## STAFF REPORT

### HISTORIC DOWNTOWN ADVISORY COMMISSION

Applicant: Mathew Althouse for Dustin Sun  
Location: 26 W Olentangy Street  
Existing Zoning: Downtown Business District (DB)  
Request: To review a proposal to change the previously approved front elevation of the building.

1  
A2.1 EXTERIOR ELEVATION - SOUTH  
1/4" = 1'-0"

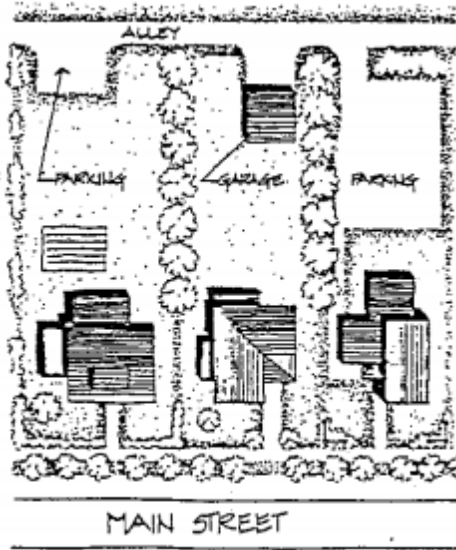
- The proposed project is in line with site considerations of the PAG.
  - Access to rear yard parking lots and storage or garage buildings should be from alleys whenever possible.
    - The proposal has designed their parking lot in this fashion.
  - Commercial lots should be paved with asphalt, brick, concrete, or tar and chips as required in the Powell Zoning Code.
    - Renderings show an asphalt type of pavement.

RIBBON WINDOW

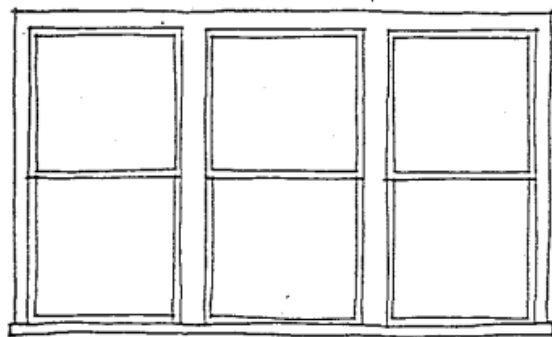
- The proposed project is somewhat in line with the PAG.
  - The front elevation of the proposal displays the Ribbon style, one of the three historically correct window styles with a 2-over-2 pattern. (Page 48)
    - Further examination by the Powell Architectural Advisor and HDAC is needed to determine whether the panels above the front windows are appropriate.
